TECHNICAL BULLETIN

412-21-245

MODEL AFFECTED: 412EP

SUBJECT: AIR DATA COMMAND DISPLAY AL-300 CABLE ASSEMBLY, MODIFICATION OF

Figure 1 - Wiring Diagram 412-475-828-101

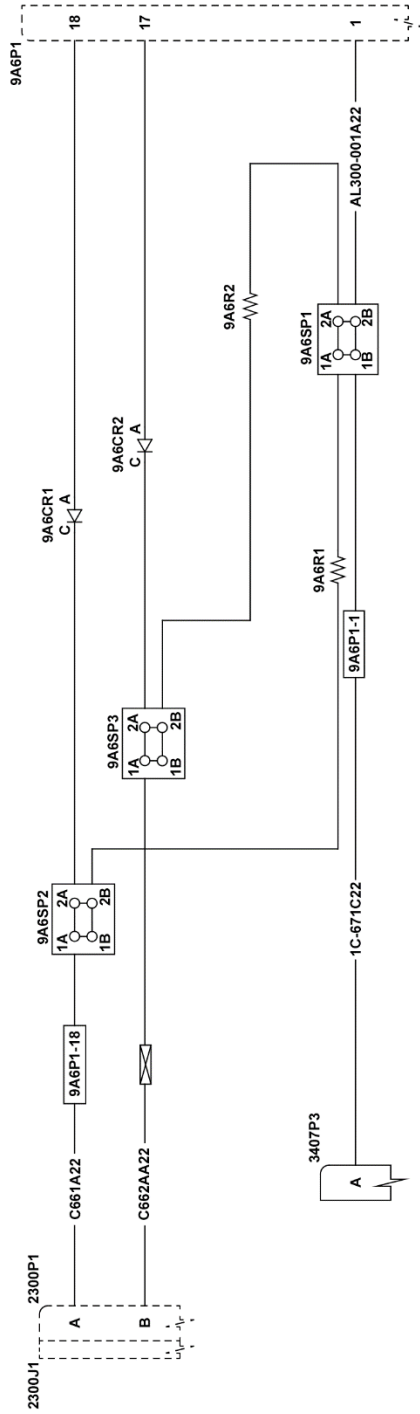
Bell has received reports of Air Data Command Display (ADCD) AL-300 flickering due to variations of ambient temperature. It has been established that changes in ambient temperature may affect the signal quality from the Flight Control Computers (FCC) and cause flickering of the ADCD AL-300. This Technical Bulletin provides the instructions for the installation of isolation diodes with pull up resistors in order to maintain the signal quality during ambient temperature changes and prevent the AL-300 display from flickering.

13. Use crimping tool M22520/7-01 and positioner M22520/7-11 to install new contacts M39029/22-191 on wires C661A22, C662AA22 and 1C-671C22.
14. Position cable assembly 412-079-828-105 over the AL 300 harness.
15. Insert wire C661A22 into position 1A of splice 9A6SP2 using insertion tool M81969/14-01. Refer to wiring diagram figure 1.
16. Insert wire C662AA22 into position 1A of splice 9A6SP3 using insertion tool M81969/14-01. Refer to wiring diagram figure 1.
17. Insert wire 1C-671C22 into position 1B of splice 9A6SP1 using insertion tool M81969/14-01. Refer to wiring diagram figure 1.
18. Insert wire AL300-001A22 into pin 1 of connector 9A6P1 using insertion tool M81969/14-01. Refer to wiring diagram figure 1.

19. Insert lead wire of 9A6CR1 into pin 18 of connector 9A6P1 using insertion tool M81969/14-01. Refer to wiring diagram figure 1.
20. Insert lead wire of 9A6CR2 into pin 17 of connector 9A6P1 using insertion tool M81969/14-01. Refer to wiring diagram figure 1.

24. Use a multimeter to perform a continuity check of the affected wires for the AL 300. Refer to wiring diagram figure 1.
25. Measure the resistance between pin 1 of connector 9A6P1 and the Air Data Dis circuit breaker 3410CB3. The resistance value should be 0 to 2 ohms.

26. Measure the resistance between pin 1 of connector 9A6P1 and pin 23 of connector 9A2J1B of FCC number 2. The resistance value should be approximately 2.2K ohms.

27. Measure the resistance between pin 1 of connector 9A6P1 and pin 24 of connector 9A2J1B of FCC number 2. The resistance value should be approximately 2.2K ohms.

28. Select the diode mode on the multimeter, place the red lead in pin 18 of connector 9A6P1 and place the black lead to pin 23 of connector 9A2J1B of FCC number 2. Measure the voltage across diode 9A6CR1, the reading should be 0.3 to 0.7 VDC.

29. Select the diode mode on the multimeter, place the red lead in pin 17 of connector 9A6P1 and place the black lead to pin 24 of connector 9A2J1B of FCC number 2. Measure the voltage across diode 9A6CR2, the reading should be 0.3 to 0.7 VDC.

Figure 2 - Cable Assembly 412-079-828-105

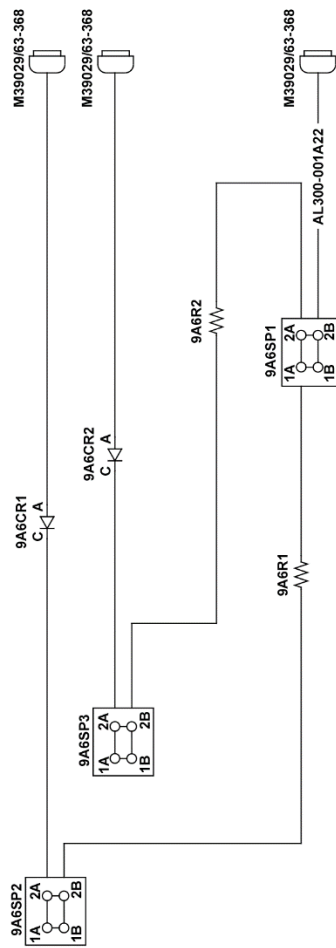
Note 2: Cable Assembly 412-079-828-105 is made of the following parts:

<u>Part Number</u>	<u>Nomenclature</u>	<u>Qty</u>
M22759/41-22-9	Wire	1
110-182H2201XBR	Resistor Assy	2
130-061-02W4	Ident Tubing	7
130-065-22-2	Term Junction	3
30-251-74BC	Diodes Assy	2 (1)
M39029/22-191	Contact	5
M39029/63-368	Contact	3

Note 1: For spare part replacement replace contact M39029/22-191 by contact M39029/63-368 on the anode side of Diodes Assy 30-251-74BC.
